**Project: IEEE P802.15 Working Group for Wireless Personal Area Networks (WPANs)**

**Submission Title:** [Radio Specification Analysis of Draft FSK PHY]

**Date Submitted:** [11 March 2012]

# FSK PHY Radio Specification and Regulatory Compliance

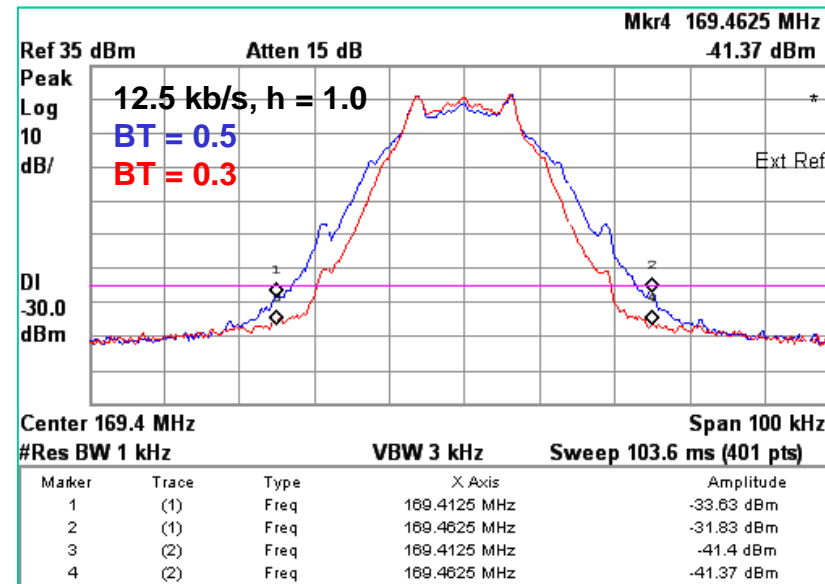
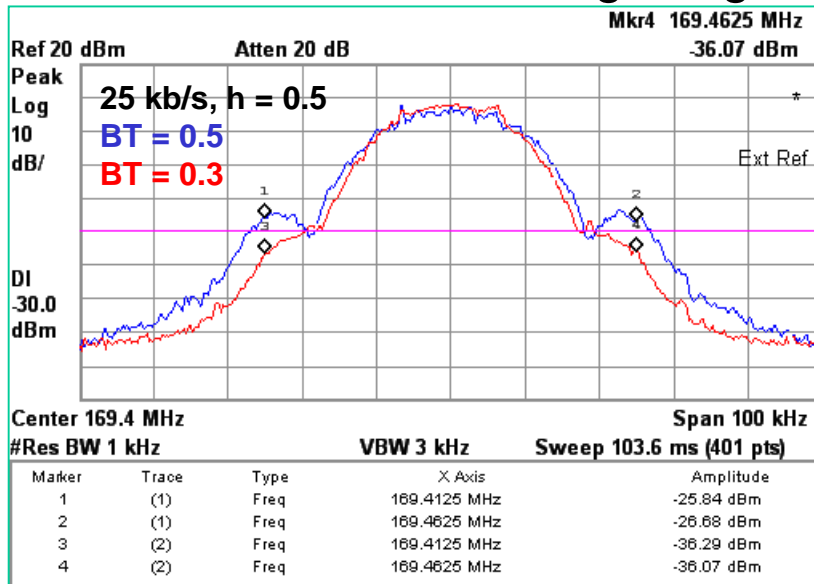
- European 169 MHz Band Proposal
- Transmit spectral mask analysis
  - ETSI EN 300 220-1 Section 7.7 (Modulation BW) applies
  - At band / channel edge, signal must be at least -30 dBm / 1 kHz RBW

- 25 kb/s ERP ~ 10 - 25 mW depending upon TX source
- 12.5 kb/s ERP ~ 500 mW if BT = 0.3
  - BT = 0.3 increases Eb/No requirements at RX
- Only single channel specified: Network capacity issues

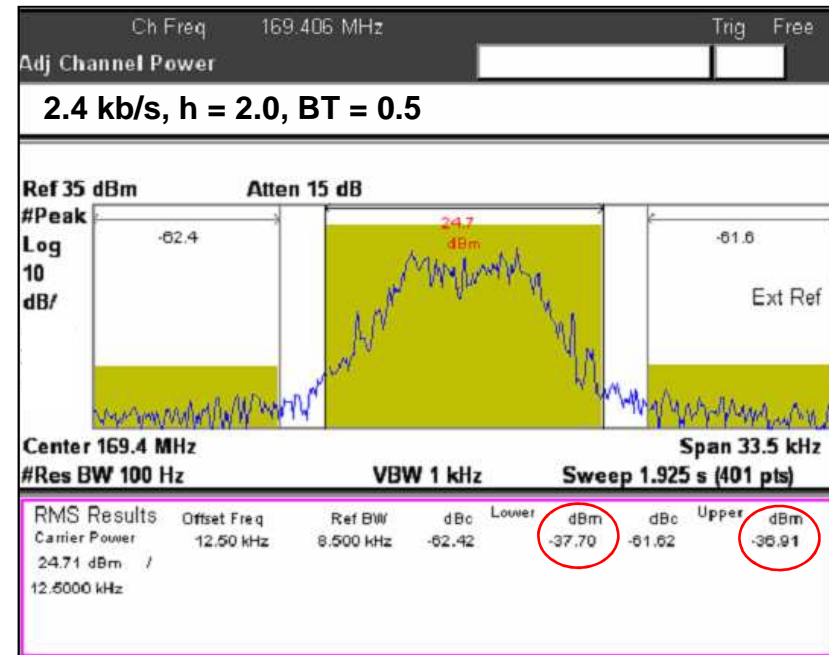
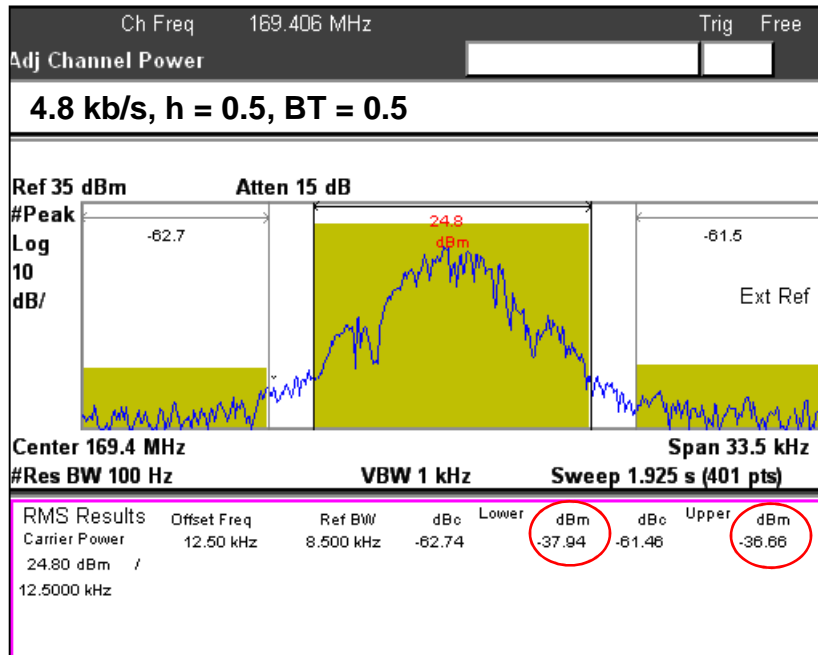
- European 169 MHz Band Proposal
- Transmit spectral mask analysis
  - ETSI EN 300 220-1 Section 7.6 (Adjacent Channel Power) applies
  - Adjacent channel power must be at least  $10 \mu\text{W}$  (-20 dBm) / 8.5 kHz BW

- Phase noise / spectral regrowth will limit maximum TX output power
- 6 channel available
